SVE BULLETIN

QVM Bulletin: Q-300 Date: 23, Jan 2020

NVH Cover Over PTO Opening 10R Transmission Super Duty Chassis Cab

Models Affected: 2020 Model Year Ford Super Duty Vehicles

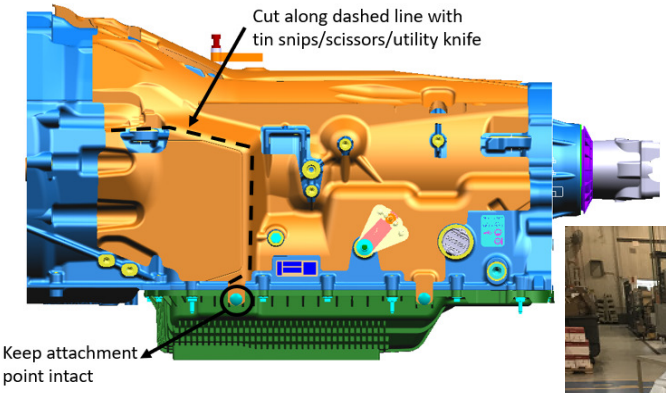
This bulletin is to address 2020 Model Year Ford Super Duty Chassis Cab equipped with a transmission NVH cover which may interfere with PTO installation. The recommended solution is to cut away a portion of the NVH cover to provide clearance for PTO device installation. It is important to cut away portion of the NVH cover, shown in the images below. Please make sure that the lower attachment point is left intact to still secure the remaining portion of NVH cover to transmission, reference images below. ***EXCERCISE CAUTION WHEN REMOVING COVER – AVOID ANY DAMAGE OR SEVERING OF TRANSMISSION, WIRING AND/OR FLUID LINES.***
